Summary Radiation Protection MAC Subgroup December 2009 and (preliminary) answers to 5 items formulated by the Subgroup

Summary (1/2) Topics MAC Subgroup workshop

Summary (2/2) Mandate for MAC Subgroup

1.) Cost Comparison (by ion 42)

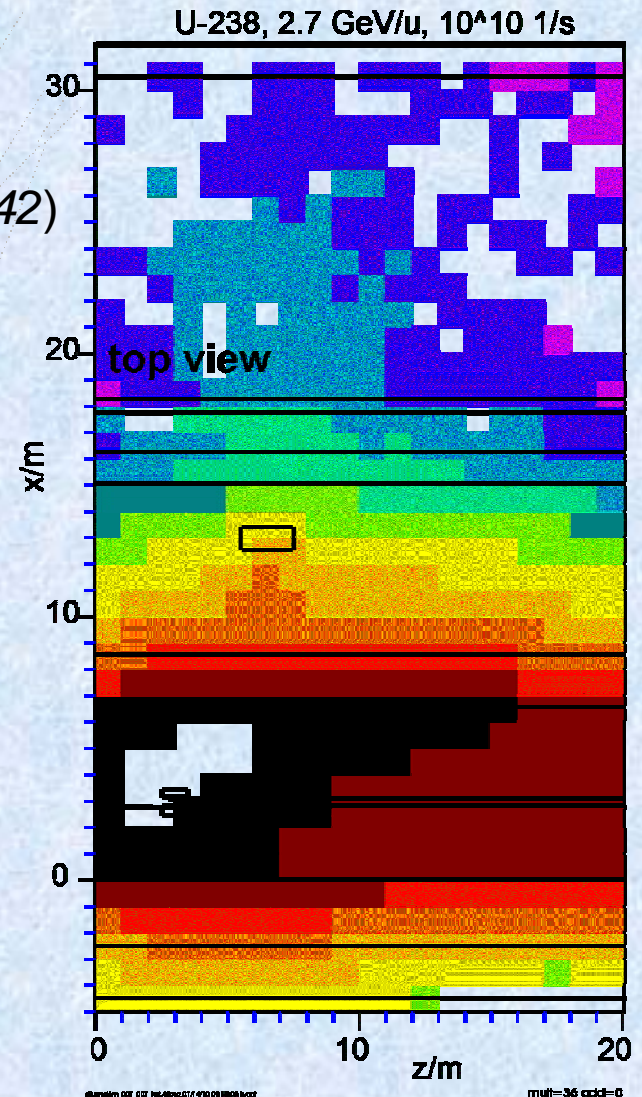
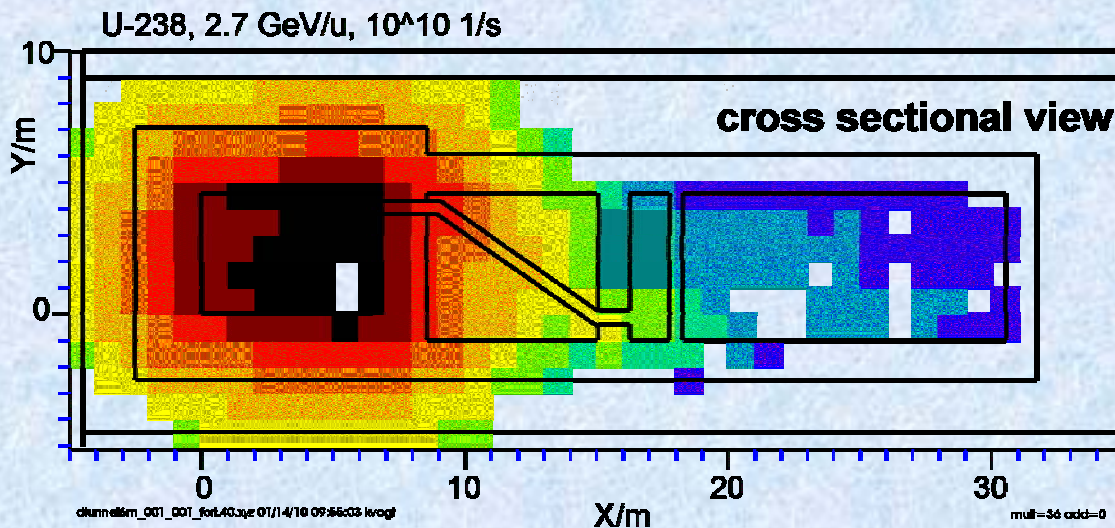
Costs that can be cut as a result of eliminating the pocket of soil between the radiation-, and service tunnel T110:

By merging the tunnels 110 (SIS 100/300) and service tunnel 110a to create a gapless wall to wall situation instead of the current planning decision of both tunnels maintaining 8m distance to each other, the following **reduction of costs** for the KG 300 can be determined:

A detailed cost comparison for the tunnel variations could be produced once the user requirements have been determined during the course of further planning.

3.) Roofs and Fencing 1/2

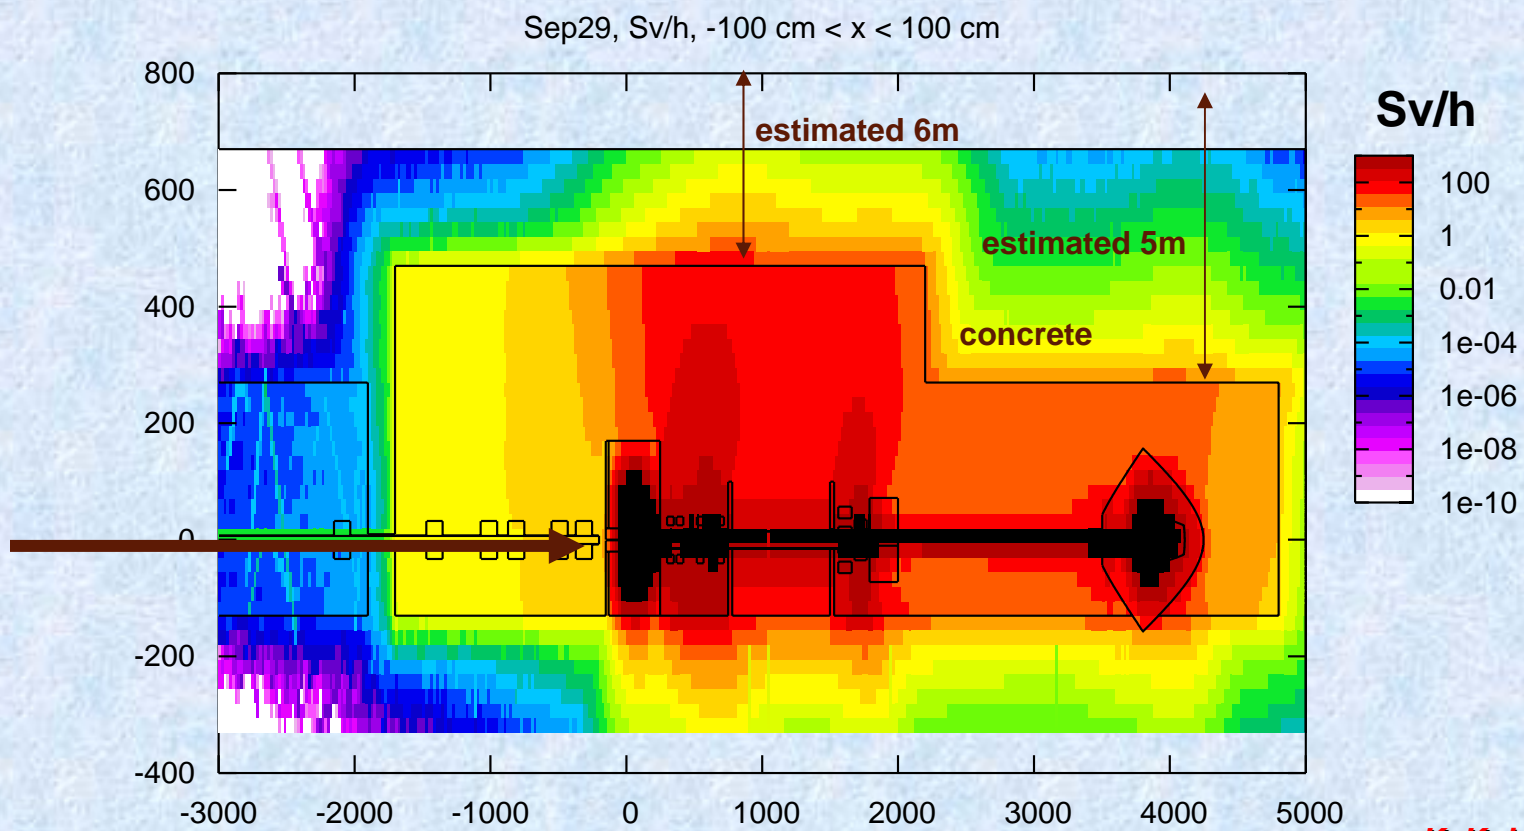
ion 42: The architects are aware of the substantial dimensions of the shielding for the buildings G006c and G014. They are the result of the shield dimensioning during the initial planning process. Due to many factors of dependency within the buildings, the architects would suggest an optimization of the concrete shielding, i.e. a review for simplification of construction through use of soil or fencing in the course of the next planning steps.

Proposals for fenced areas (in blue)

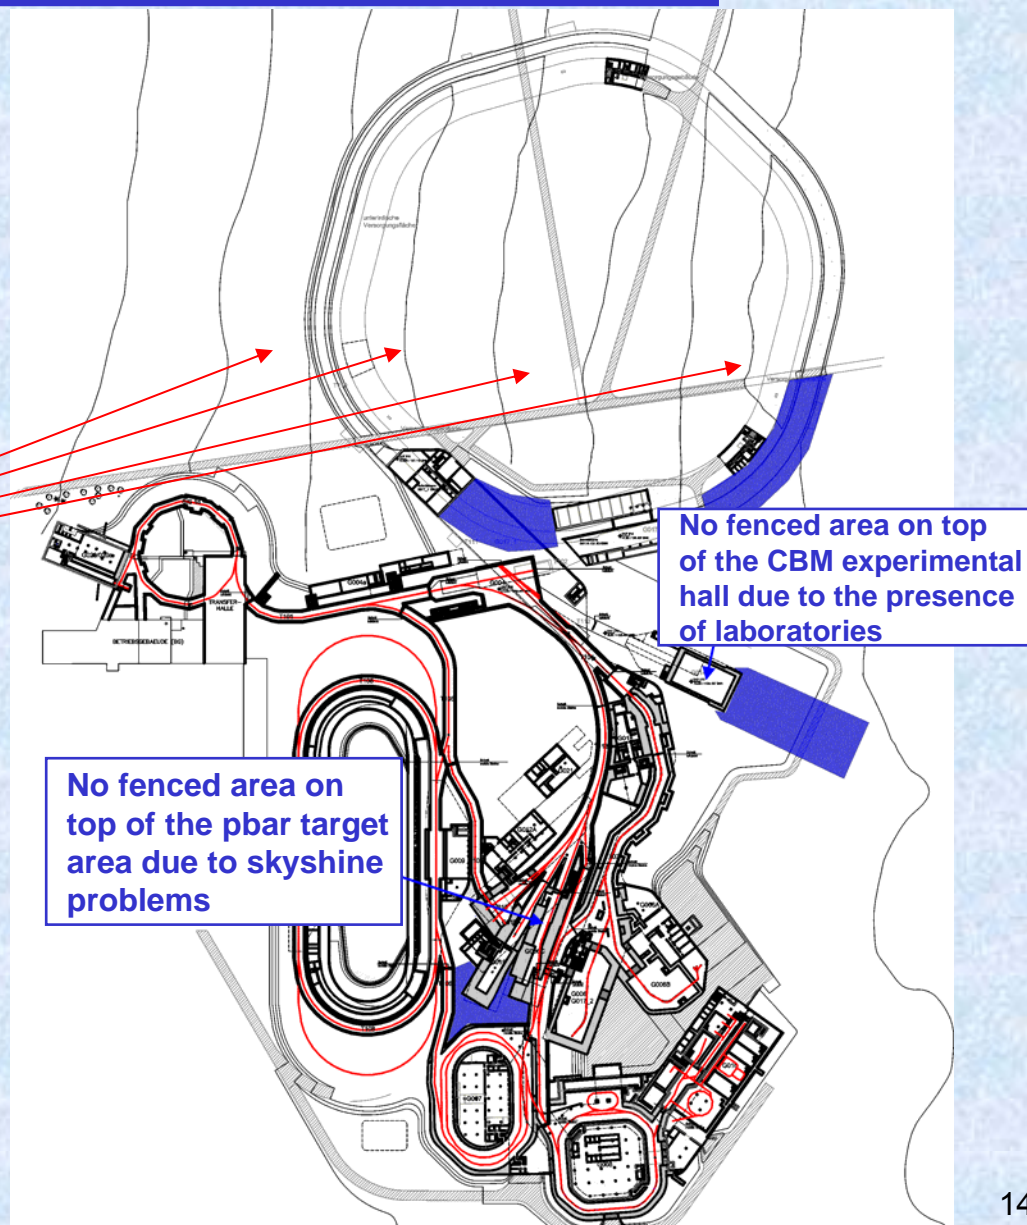
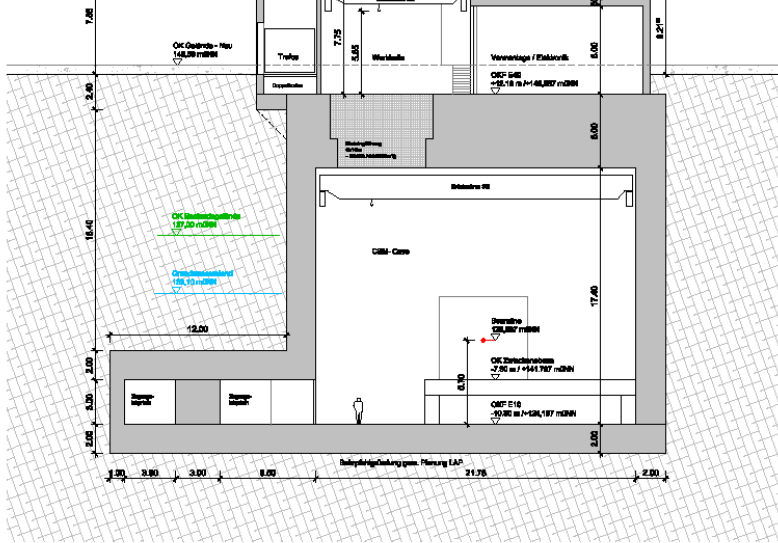
- Paths for transportation on the premises should not be blocked by fenced areas (possible in case of the CBM beam dump area)
- No fencing on public ground
- Authorities have stated according to §43 StrlSchV (German radiation protection ordinance) that the radiation safety of the personnel has to be assured prior-ranking by proper enclosing solutions, i.e. the use of shielding has to be considered for most cases. Fencing can only be used in exceptional circumstances.

Partial Replacement of Concrete by Soil

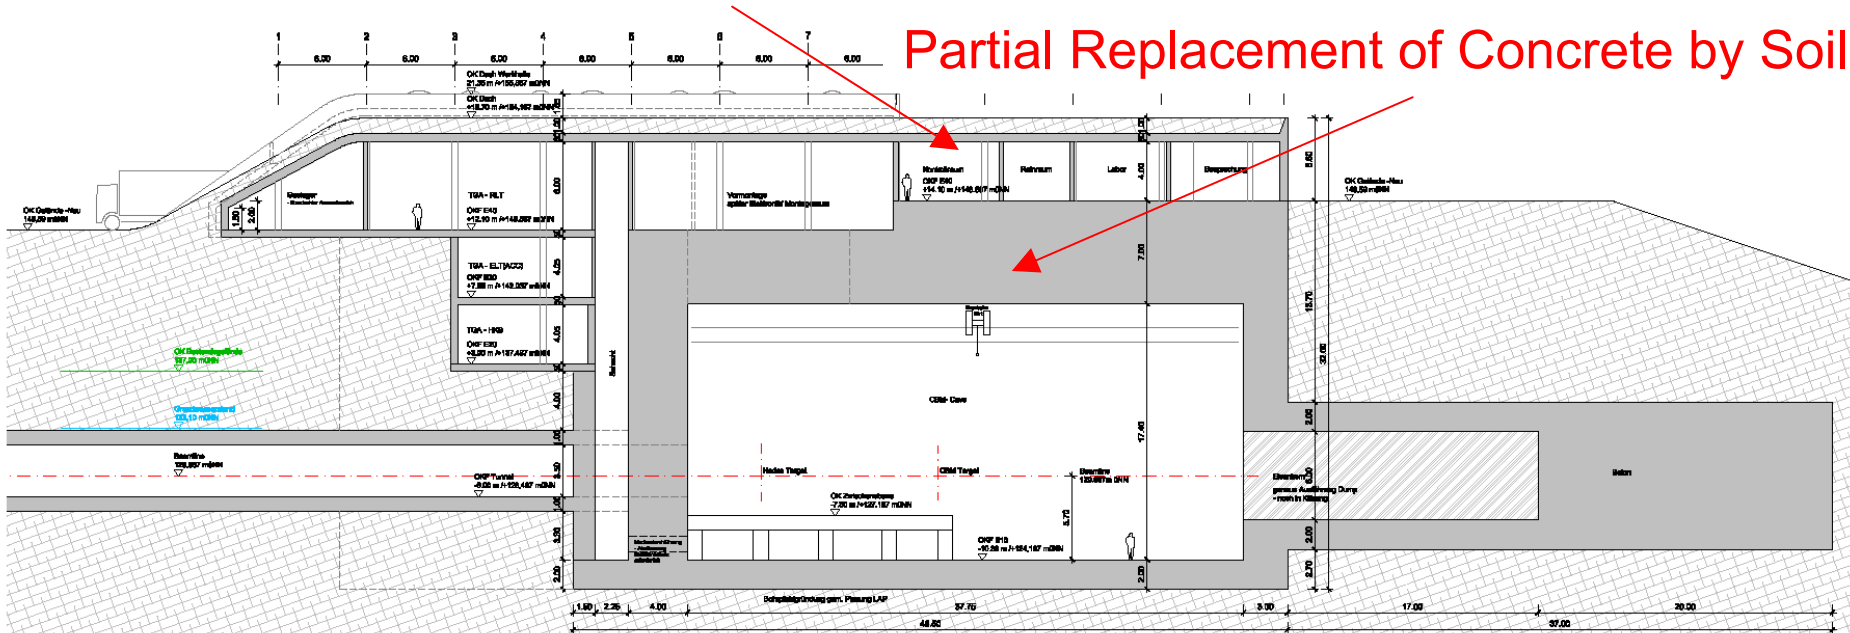
Technical/Stay Areas will be moved

Sandwich Shielding =
Combination of Steel/Concrete Shielding

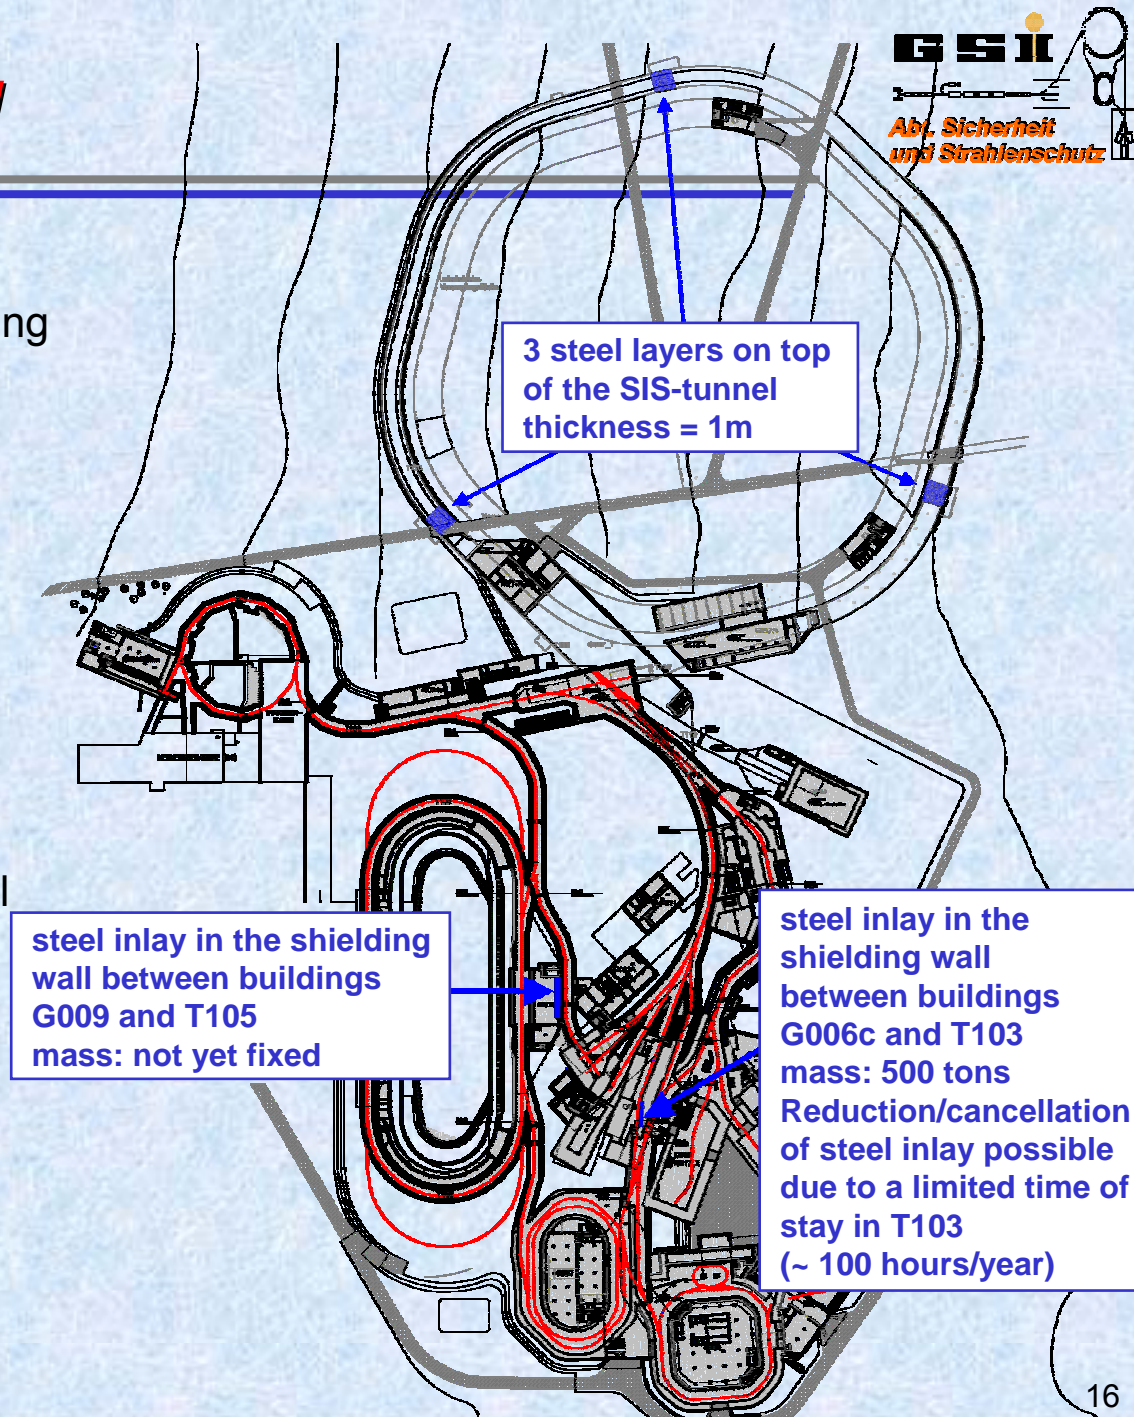
1. Sandwich shielding has only been foreseen in places where a severe problem of space prevents the use of ordinary concrete shielding. → Revision of access concepts (duration of stay, cut/change of beam lines) will lead to a cancellation of sandwich shielding
2. The possible chemical contamination of cheap steel is well known at GSI.
3. Calculations for the activation of steel as a function of its composition have already been performed.

5.) Building No. 21 (Area for storage, radioactive decay and clearance of activated components)

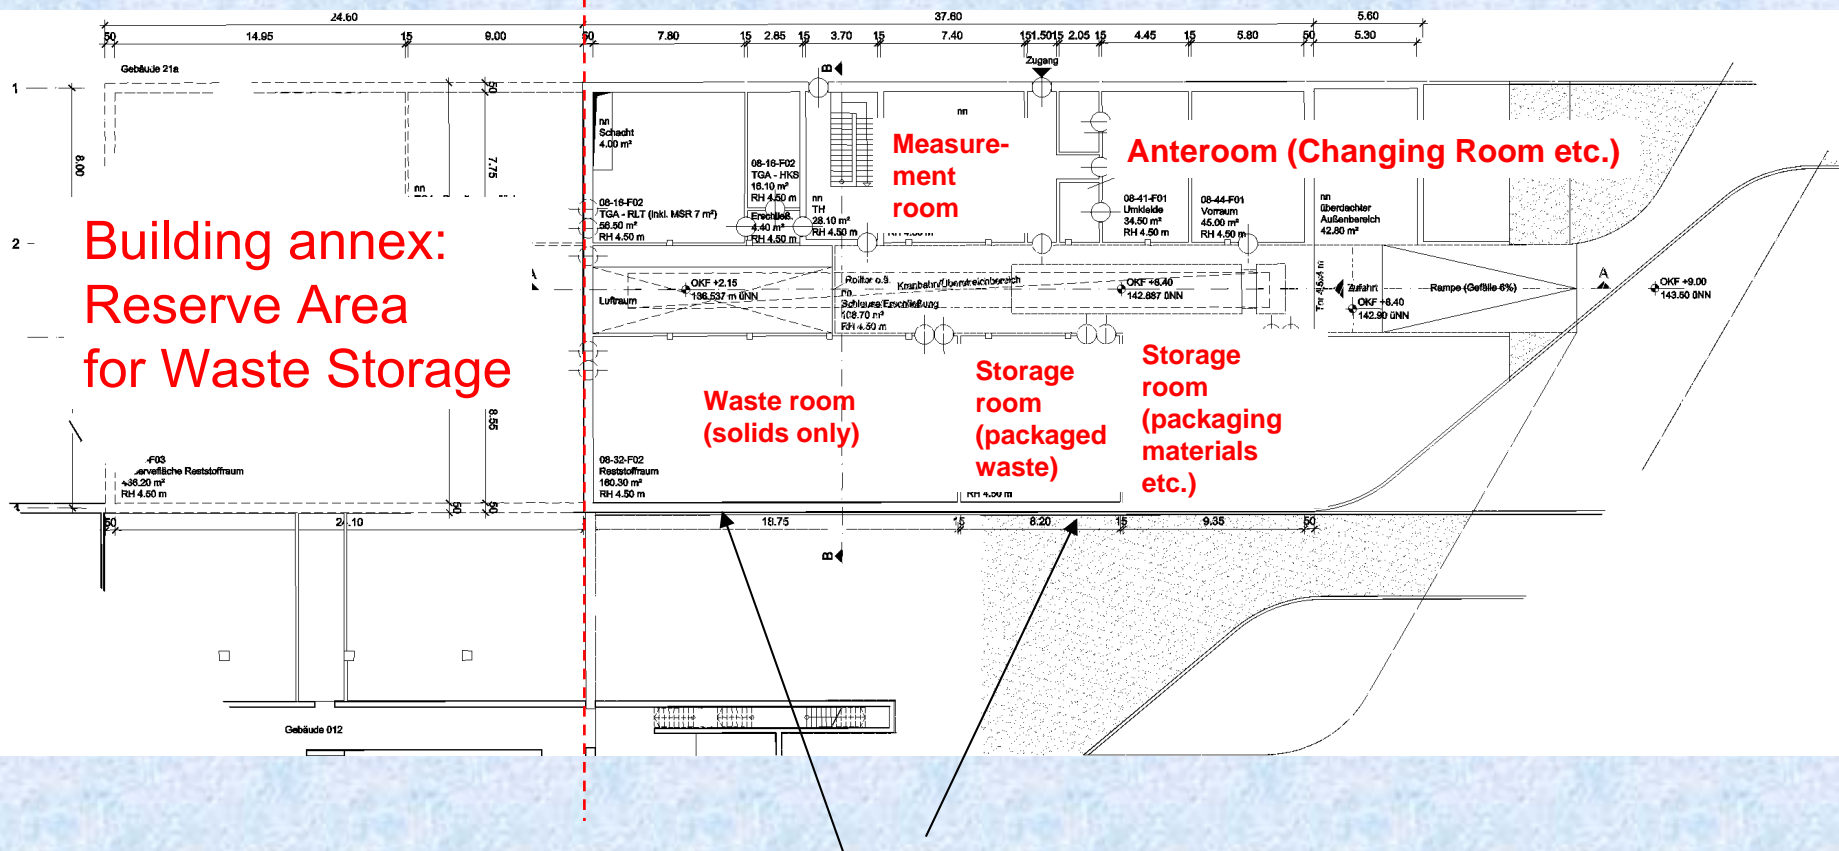
Start with a comparatively small building,
extension of the building parallel to the development of FAIR

hot workshop can/should be implemented in starting/extended version of building 21
